# **Supplemental Watershed Plan-Environmental Assessment for the Pohick Creek Watershed**

Supplement No. 5 to the original watershed plan for the rehabilitation  
of Pohick Creek Dam No. 2 (Lake Barton)

**Watershed Plan-Environmental Assessment for the rehabilitation of Pohick Creek  
Watershed Dam No. 2 (Lake Barton)  
Fairfax County Department of Public Works and Environmental Services  
Comments  
June 19, 2009**

# Lake Barton Land Ownership

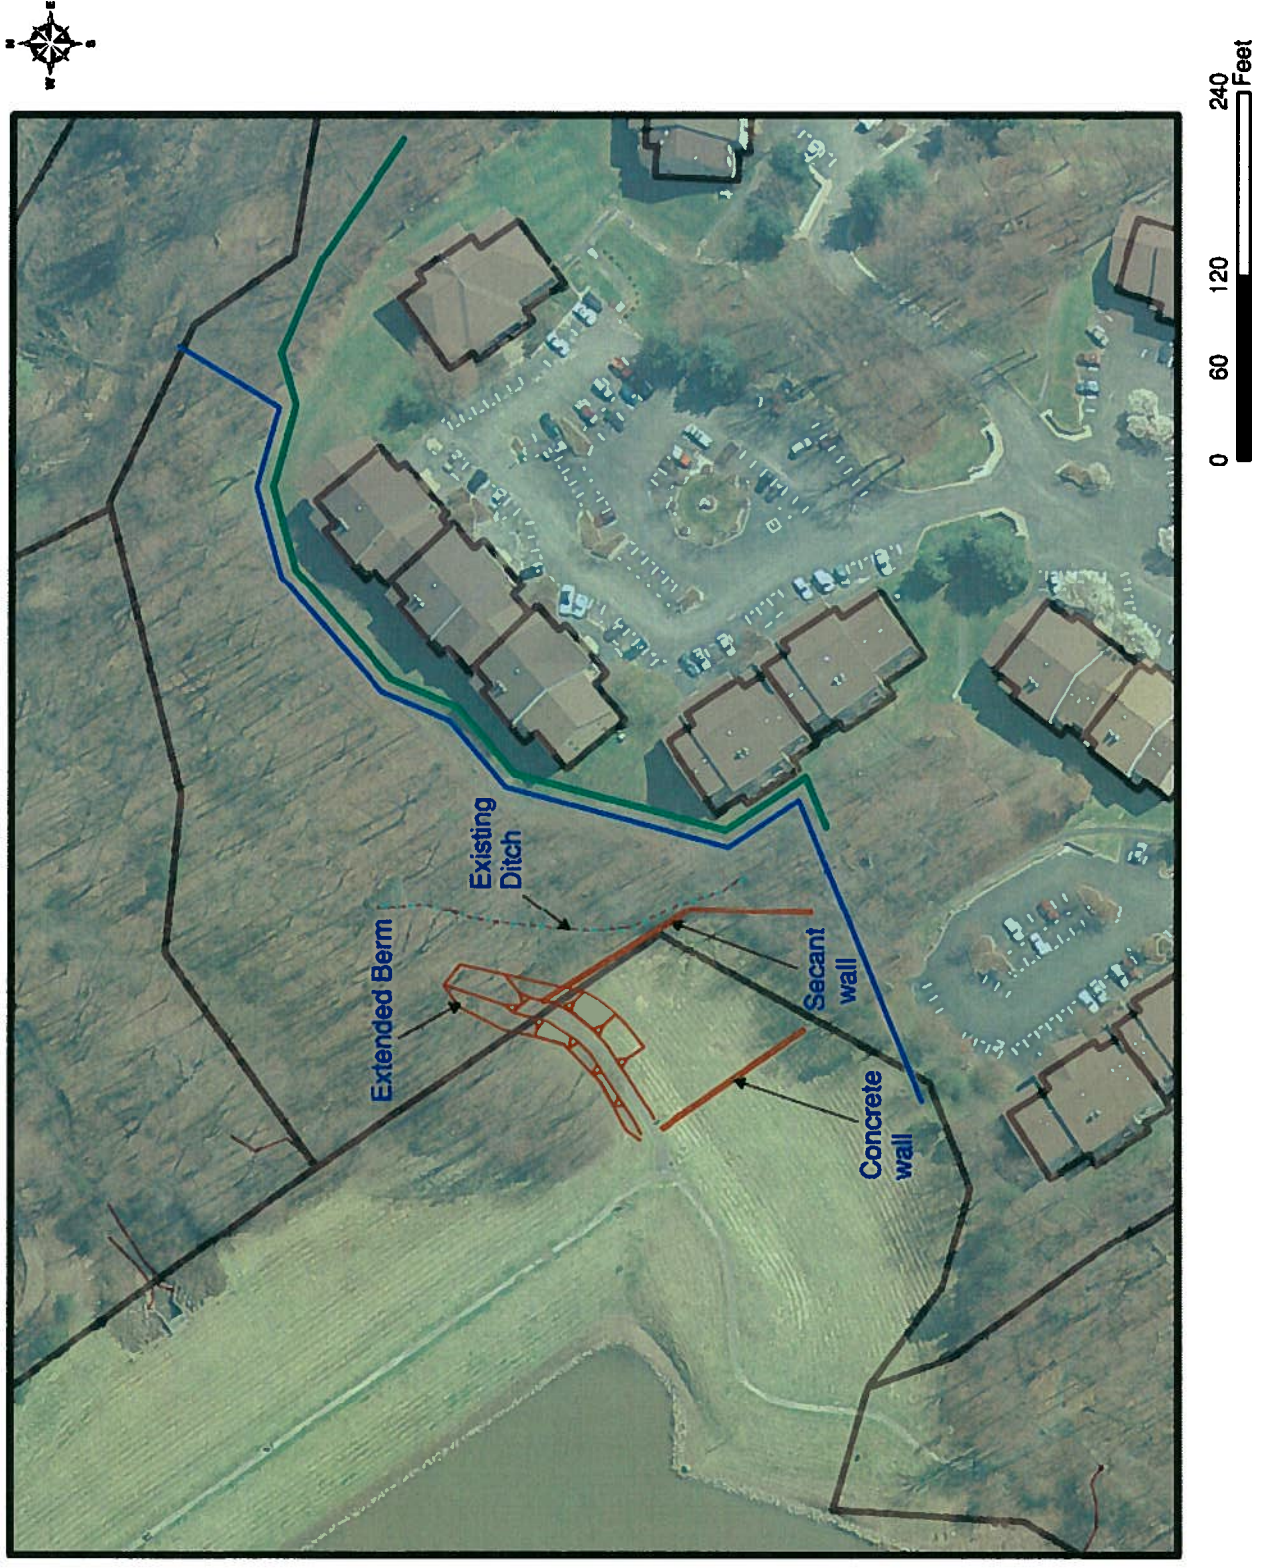
14. We recommend replacing Figure D1 with the attached figure (Lake Barton Land Ownership) which more clearly shows land ownership by parcel and also conceptually shows the proposed construction access road alignment. We also suggest including the attached figure (Preferred Spillway Rehabilitation Option) as an additional Figure D8, that shows the preferred rehabilitation alternative in plan view over an aerial photo base for better visualization of this alternative.
